## **SERVICE BULLETIN #142 May 18, 1998** -Engineering Department-

In order to keep all **MiTek<sup>®</sup> Cyber Saws<sup>®</sup>** up to date with new designs we are issuing a service bulletin to all **MiTek<sup>®</sup> Cyber Saw<sup>®</sup>** owners. The following changes should be made and/or the following should be checked.

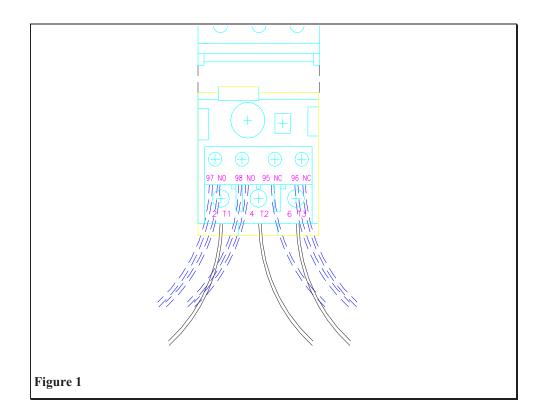
In Cyber Saws<sup>®</sup> out at customer sites, the overload for the blade angulation, hold downs and lumber stop was at a ampere value of 0.4-.65A (MiTek<sup>®</sup> P.N. 514143). This is too low considering the requirement on motor plate is 0.72A. To correct this a higher load carrying overload replacement of 0.65-1.1A (MiTek<sup>®</sup> P.N. 509316) is needed. In order to replacing the overload, use the following instructions: See Figure 1. This should be done with all blade angulation, hold downs and lumber stop overloads.

- Shut down saw through proper procedure and then turn power off at main disconnect switch.
- Locate the overloads being replaced in Stationary and Carriage Enclosure. Pull drawer out after locating.
- At each overload, remove wires at these terminals. 97NO(black wires), 98NO(red input wires), 95NC(red wires) and 96NC(white wires), then at T1, T2 and T3 (motor leads).
- Loosen screws at T1,T2 and T3 terminals at contactor.
- Remove overload by pulling away from contactor.

- Install new overload. Make sure the three prongs on the overload line up with T1, T2 and T3 slots under the contactor.
- At each overload, tighten the screws at T1, T2 and T3 terminals snug and properly.
- Install wires at these terminals. T1, T2 and T3 (motor leads), then at 97NO(black wires), 98NO(red input wires), 95NC(red wires) and 96NC(white wires).
- Set overload to 0.90A.
- Push drawer back into position in the enclosures.
